**ITEM 7. SECTION 96 APPLICATION: 485-521 HARRIS STREET ULTIMO****FILE NO: D/2014/1147/A****SECTION 96 APPLICATION NO: D/2014/1147/A****SUMMARY****Date of Submission:** 24 March 2016, amended 31 October 2016**Applicant:** Mr Giovanni Cirillo**Architect:** Architectus**Developer:** TWT Property Group**Owner:** Timkit Pty Ltd**Cost of Works:** \$98,739,301**Proposal Summary:** Section 96(AA) modification application to amend Stage 1 building envelopes for a mixed use development. Proposed changes include modifications to the configuration of the approved building envelope.

This Section 96 application is the result of a Stage 2 detailed design proposing to vary the building envelopes approved under a Stage 1 development consent (D/2014/1147) granted by the NSW Land and Environment Court and a subsequent design competition. Consequently, the Section 96 modification and Stage 2 development application are being assessed concurrently. Both reports are before the CSPC for review and determination.

**Figure 24:** Diagrams indicating building mass and volume to be removed (blue).

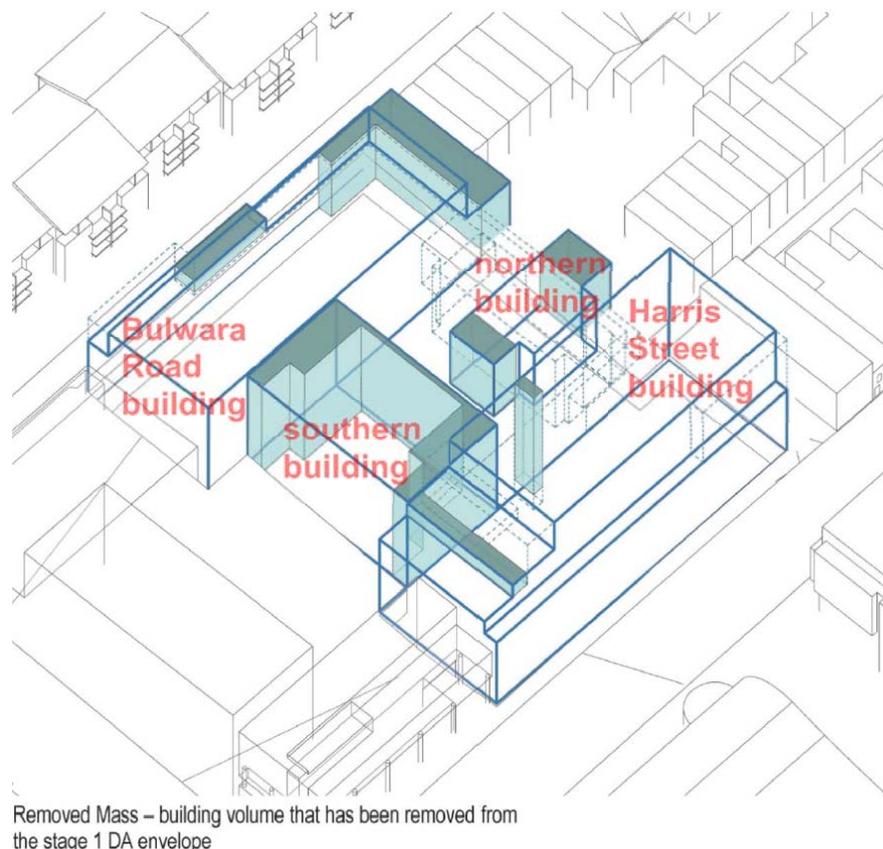
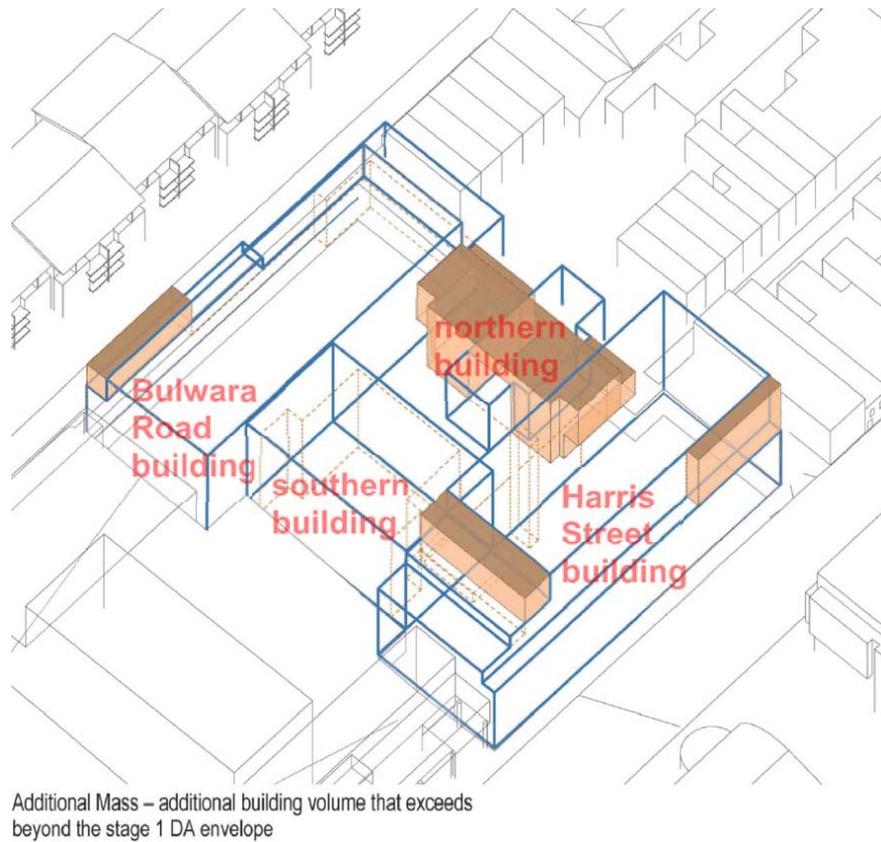
25. The subject Section 96AA application seeks to modify the approved Stage 1 building envelope to achieve consistency with the winning design scheme by Architectus.
26. In summary, the application seeks the volumetric re-configuration of the approved massing of the building envelopes across the site (as indicated in **Figures 24 and 25** below), including:
  - (a) relocation of deep soil zones;
  - (b) reconfiguration of basement levels;
  - (c) rotation of the central building 90 degrees to create a central courtyard and northern through-site link from Harris Street and Kirk Street to Bulwara Road; and
  - (d) modifications to the building envelopes to subtract building volume from the northern, western and southern sides of the site add volume to the eastern side to Harris Street.

**Figure 26:** Comparison basement plan showing proposed changes from the Stage 1 concept approval (blue) to those sought by the subject application (green)

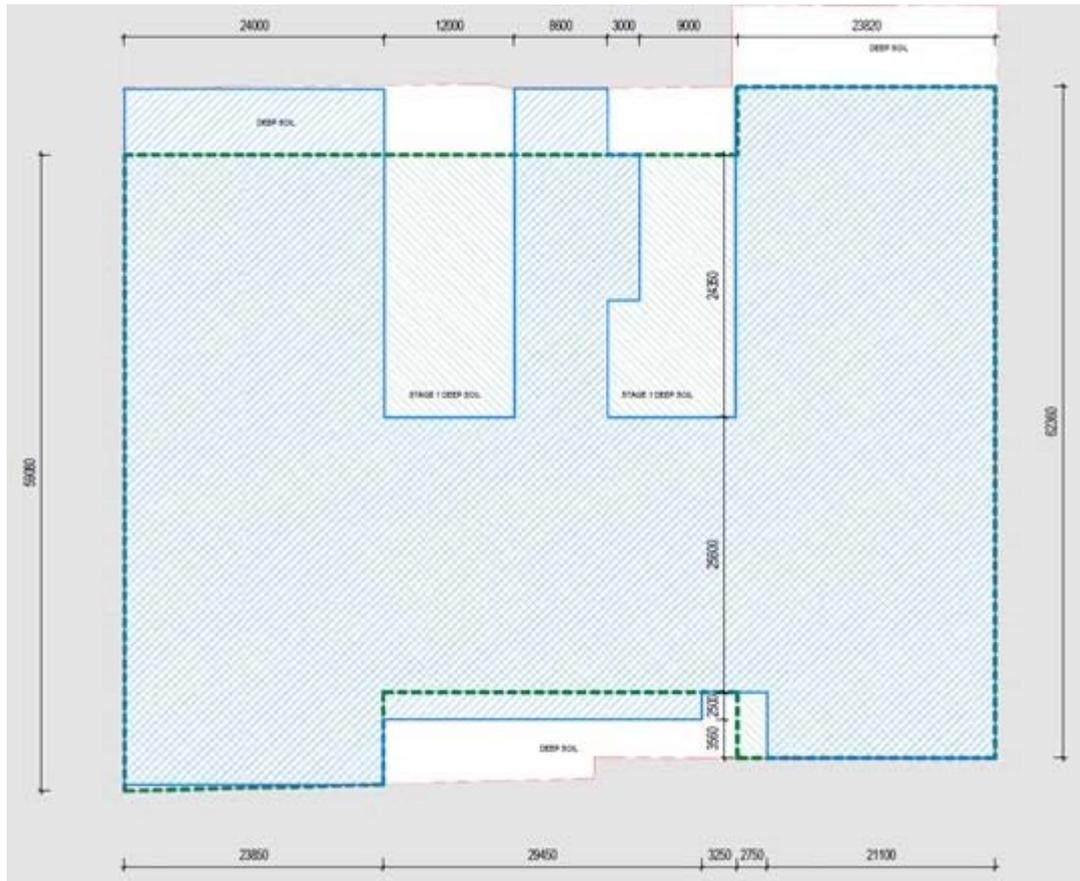
(a) **Basement Levels** (as indicated in **Figure 26**)

- (i) relocation of deep soil zones from the centre of the site to the northern and southern portions of the site;
- (ii) extension of the northern portion of the basement to Bulwara Road; and
- (iii) reconfiguration of the southern portion of the basement along the southern side boundary.

**Figure 27:** Comparison ground floor plan showing proposed changes from the Stage 1 concept approval (blue) to those sought by the subject application (green)

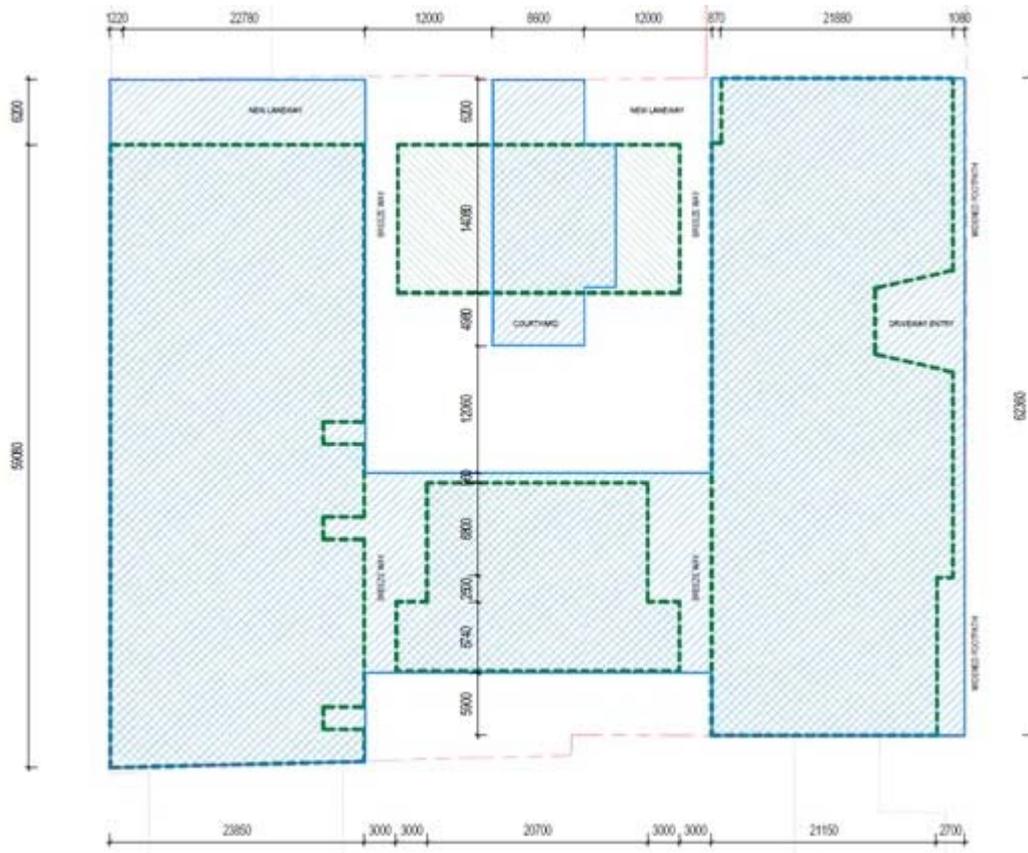
- (b) **Ground Floor Level** (as indicated in **Figure 27**)
- (i) Reconfiguration of the dimensions and rotation of the central building by 90 degrees with a setback of 6.2 metres from the northern side boundary and 3 metres from the Harris Street and Bulwara Road buildings;

- (ii) Separation of the southern building from the Harris Street and Bulwara Road buildings by 3 metres and 2.9 metres respectively;
  - (iii) Provision of a setback to the Bulwara Road building of 6.2 metres from the northern side boundary;

- (iv) Provision of indentations to the eastern side of the Bulwara Road building to accommodate pedestrian entrances;
  - (v) Provision of setbacks and indentations on the eastern side of the Harris Street building to accommodate a driveway entry, an awning and future footpath widening,

- (vi) Provision of an 870mm setback on the north western part of the Harris Street building.

The amended plans submitted on 31 October 2016 provided a further 1.2 metre setback to the Harris Street building from the northern side boundary, in order to accommodate a new walkway to the northern side of the building in the Stage 2 development application.

**Figure 28:** Comparison level 1 plan showing proposed changes from the Stage 1 concept approval (blue) to those sought by the subject application (green)

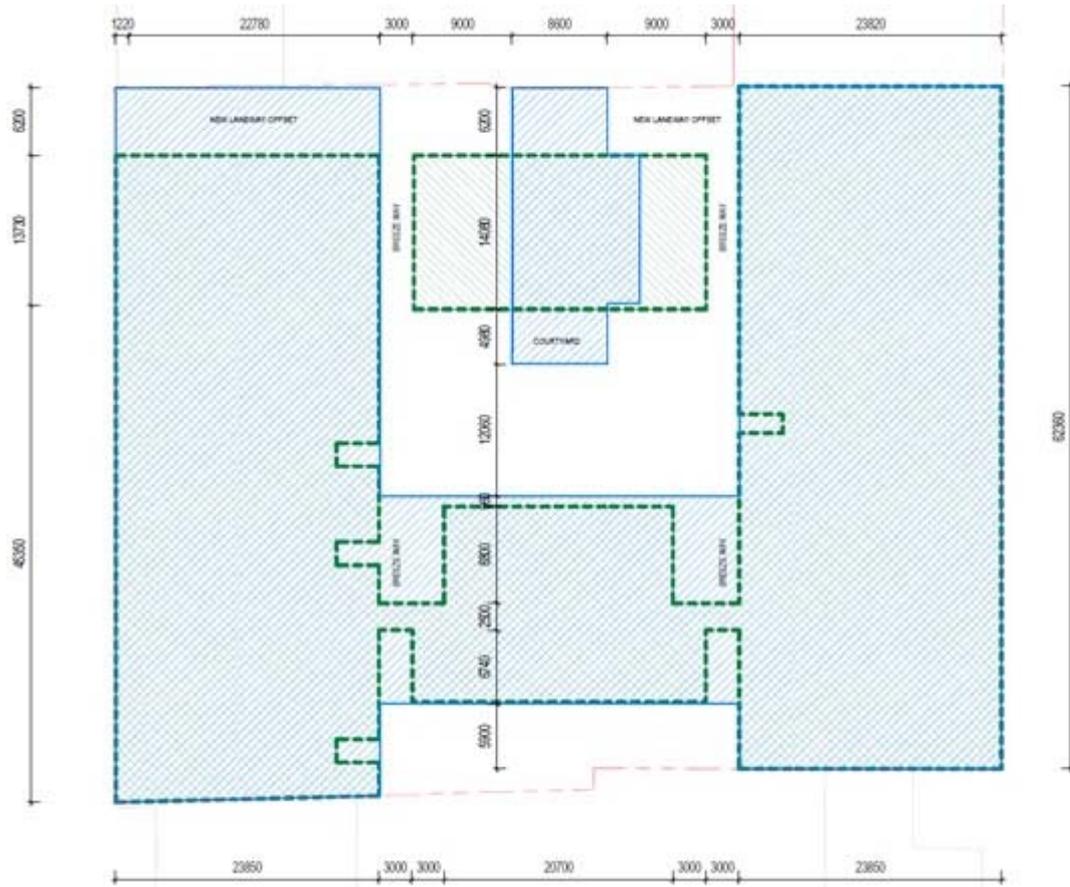
(c) **Level 1** (as indicated in **Figure 28**)

- (i) Reconfiguration of the dimensions and rotation of the central building by 90 degrees with a setback of 6.2 metres from the northern side boundary and 3 metres from the Harris Street and Bulwara Road buildings;
- (ii) Provision of indentations to the western side of the Harris Street building and eastern side of the Bulwara Road building;
- (iii) Provision of breezeway indentations to the eastern and western sides of the southern building; and
- (iv) Provision of a 1.22 metre setback from the street frontage to the Bulwara Road building for a length of 13.73 metres; and
- (v) Provision of a setback to the Bulwara Road building of 6.2 metres from the northern side boundary.

**Figure 29:** Comparison level 2 and 3 plan showing proposed changes from the Stage 1 concept approval (blue) to those sought by the subject application (green)

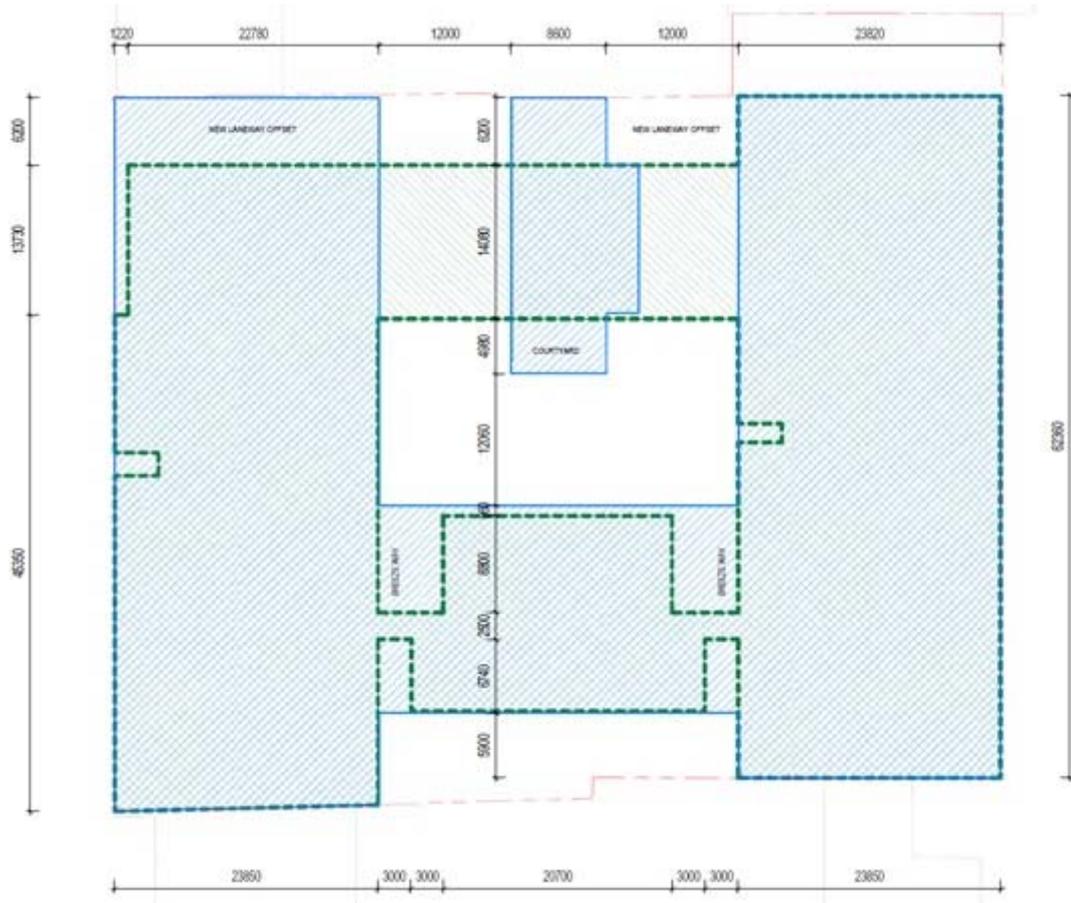
- (d) **Levels 2 and 3** (as indicated in **Figure 29**)
- (i) Reconfiguration of the dimensions and rotation of the central building by 90 degrees with a setback of 6.2 metres from the northern side boundary and no separation from the Harris Street and Bulwara Road buildings;
  - (ii) Provision of indentations to the western sides of the Harris Street and Bulwara Road buildings;
  - (iii) Provision of breezeway indentations to the eastern and western sides of the southern building; and
  - (iv) Provision of a 1.22 metre setback from the street frontage to the Bulwara Road building for a length of 13.73 metres; and
  - (v) Provision of a setback to the Bulwara Road building of 6.2 metres from the northern side boundary.

**Figure 30:** Comparison level 4 plan showing proposed changes from the Stage 1 concept approval (blue) to those sought by the subject application (green)

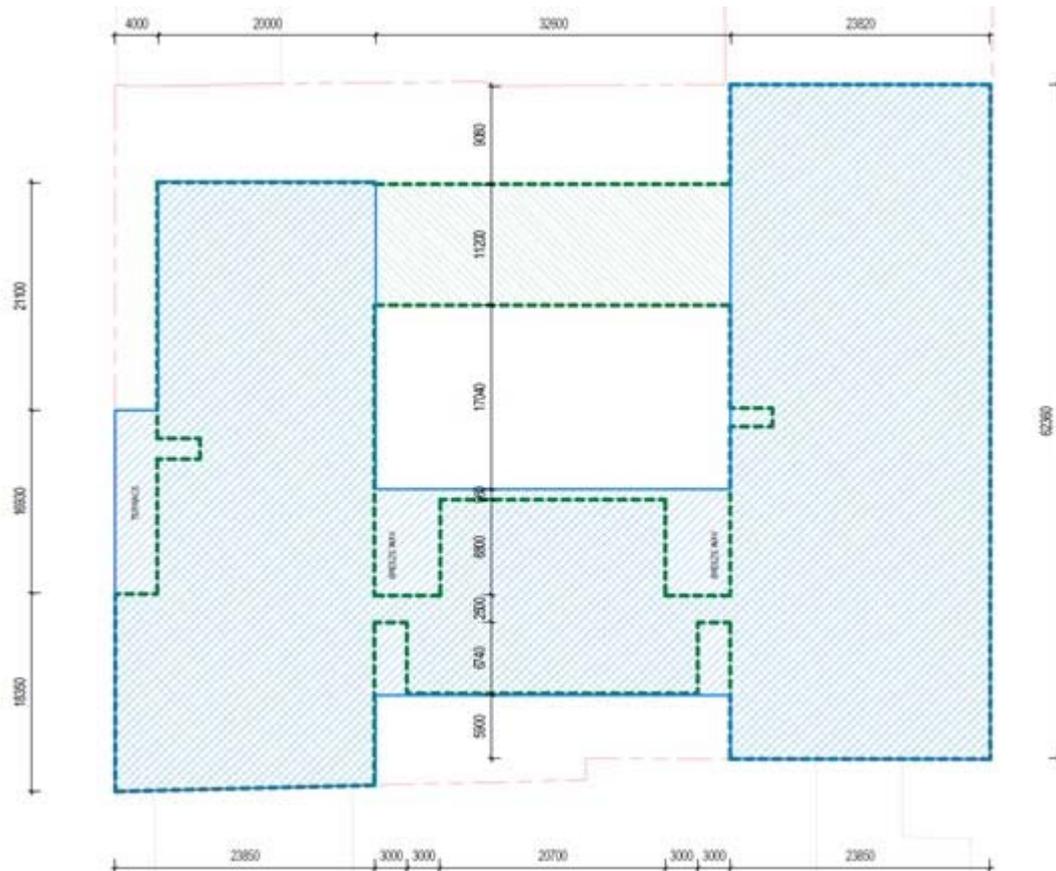
(e) **Level 4** (as indicated in **Figure 30**)

- (i) Reconfiguration of the dimensions and rotation of the central building by 90 degrees with a setback of 6.2 metres from the northern side boundary and no separation from the Harris Street and Bulwara Road buildings;
- (ii) Provision of indentations to the western sides of the Harris Street and Bulwara Road buildings;
- (iii) Provision of breezeway indentations to the eastern and western sides of the southern building;
- (iv) Provision of an additional 4 metre setback from the street frontage to the Bulwara Road building for a length of 16.93 metres; and
- (v) Provision of a setback to the Bulwara Road building of 6.2 metres from the northern side boundary.

**Figure 35:** Comparison level 9 plan showing proposed changes from the Stage 1 concept approval (blue) to those sought by the subject application (green)

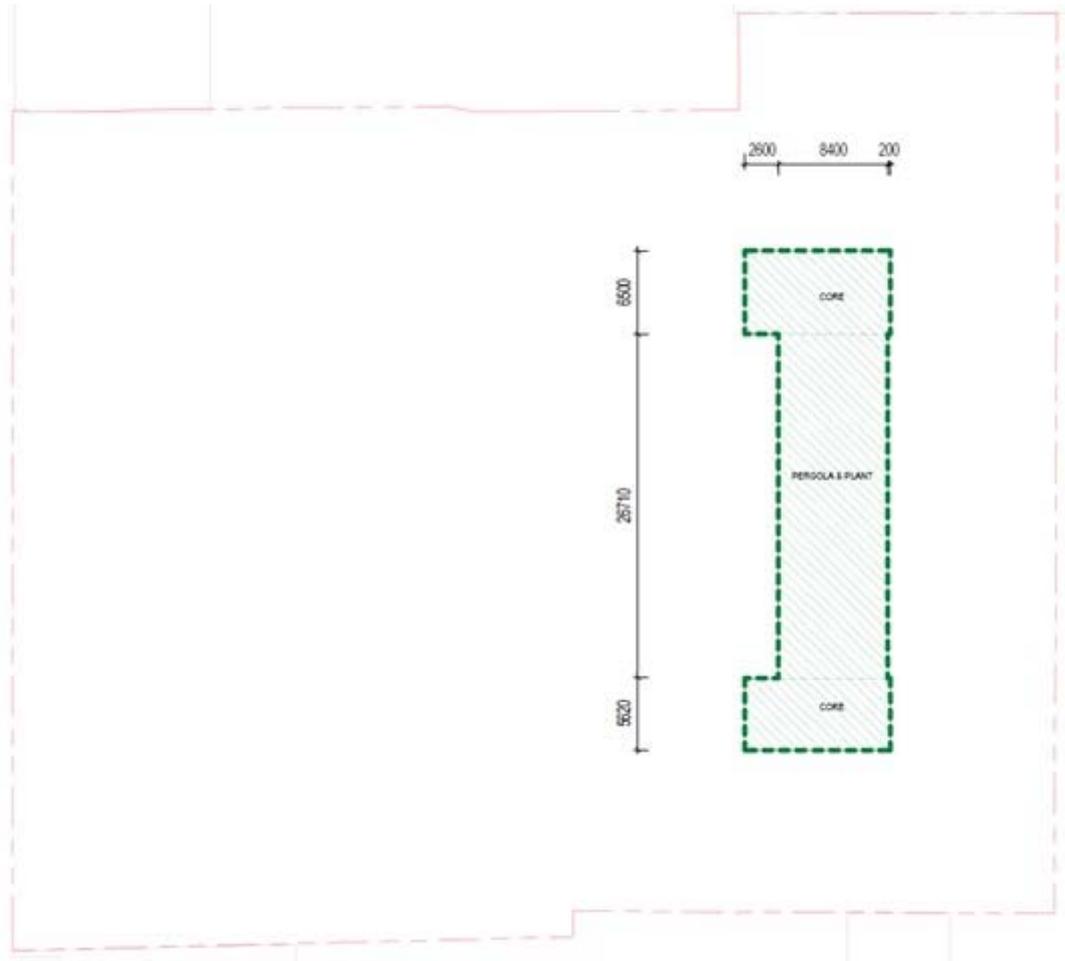
- (j) **Level 9** (as indicated in **Figure 35** below)
  - (i) Additional massing measuring 11.2 metres width by 38.83 metres length to the Harris Street building to accommodate building cores, plant and equipment within an architectural roof feature in the Stage 2 development application.

**Figure 36:** Approved Stage 1 building envelope (blue) with the 22 metre height plane (red)

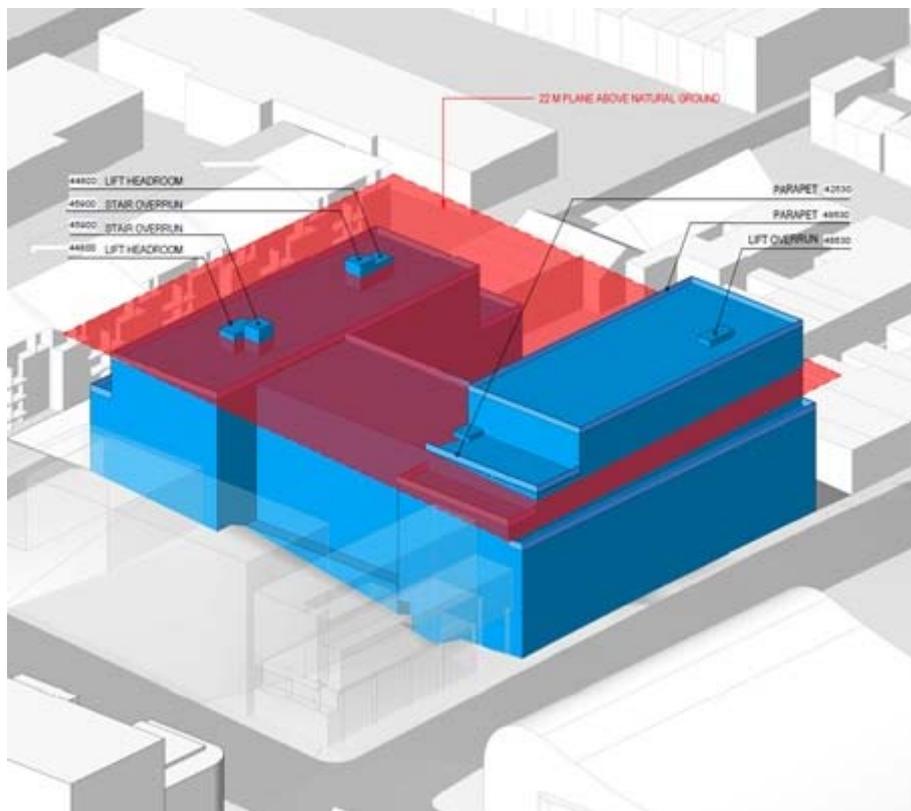
35. The Stage 1 building envelope was approved by the NSW Land and Environment Court on 23 July 2015 with a maximum height of 29.9 metres, as indicated in **Figure 36** below. This height is calculated from the lift overrun (RL 48.63 AHD) to the ground floor (RL 18.73 AHD) of the Harris Street building.

**Figure 37:** Proposed building envelope (green) with additional height and massing (pink)

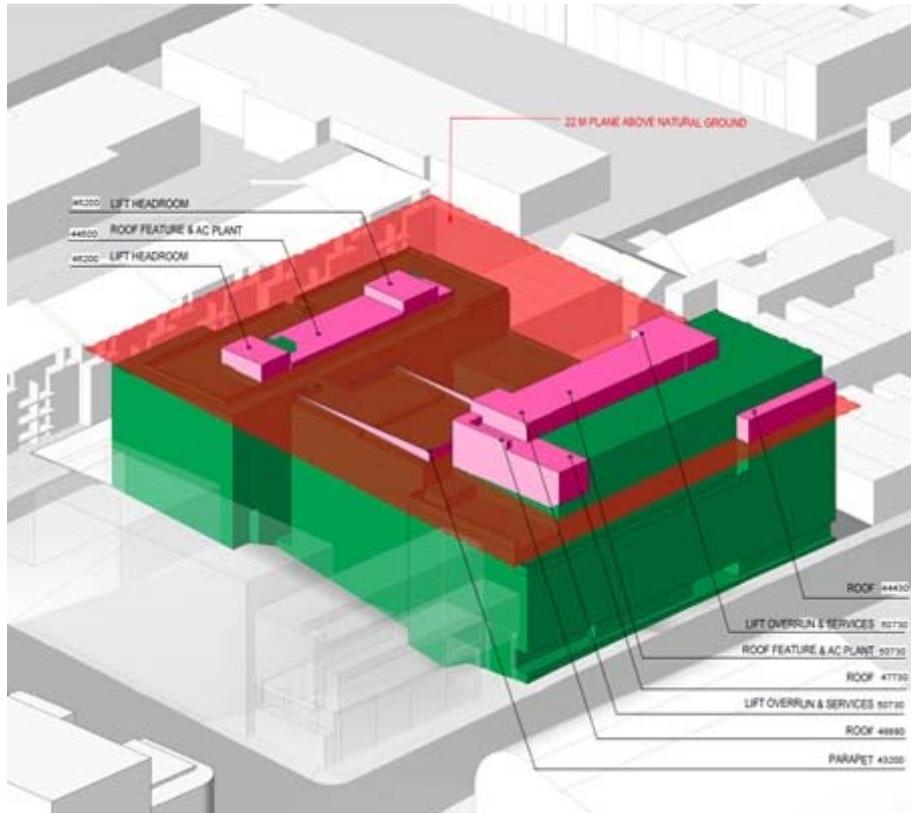
- (c) refinement of the architectural expression of the building, to redistribute bulk and massing across the site to provide the northern laneway, breezeways between the buildings and architectural roof features to screen rooftop services.
37. Proposed modifications to the overall height and massing of the approved Stage 1 building envelope are shown in the diagram in **Figure 37** below.

38. Pursuant to Clause 4.3 of the Sydney LEP 2012, the site is subject to a maximum permitted building height of 22 metres.
39. The proposal seeks to modify the approved height by redistributing massing within the development, increasing the overall height from 29.9 metres to a maximum height of approximately 32 metres. This is measured from the top of the lift overrun, plant and services (RL 50.73 AHD), to the ground floor (RL 18.73 AHD) of the building.

40. The proposed modification represents a variation from the Stage 1 approval of 7% (2.1 metres) and a maximum variation of 45.5% (10 metres) to the building height development standard.

**Figure 39:** Site plan indicating through-site link location and separation from the Ultimo heritage conservation area to the north of the site.

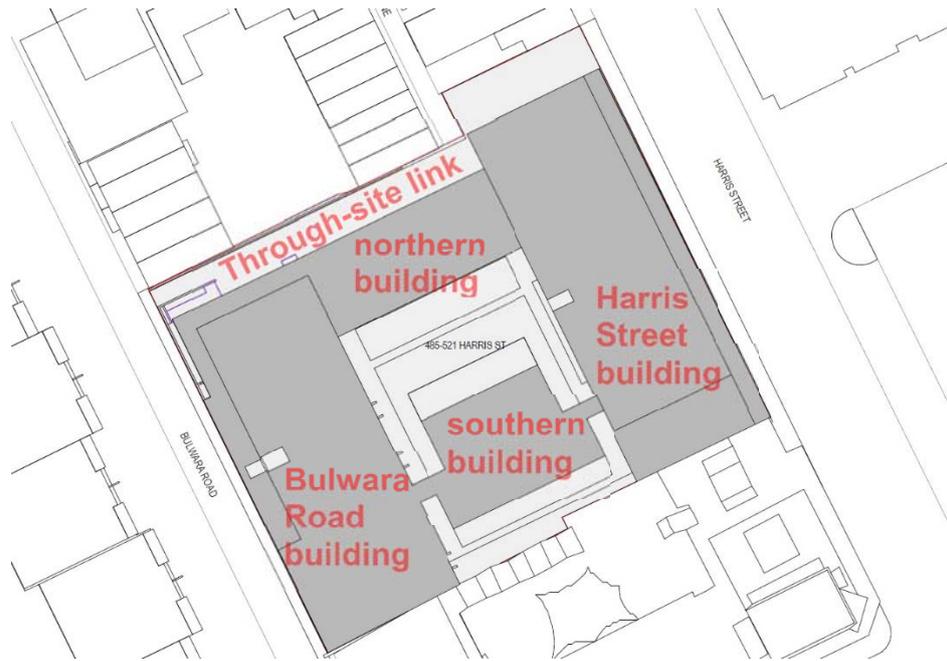
- (ii) the proposed through-site link results in a physical separation between the building envelopes from the adjoining low-scale terrace houses to the north (as indicated in the site plan in **Figure 39** below). The gap significantly mitigates the visual impact of the development on the properties within the adjacent conservation area;
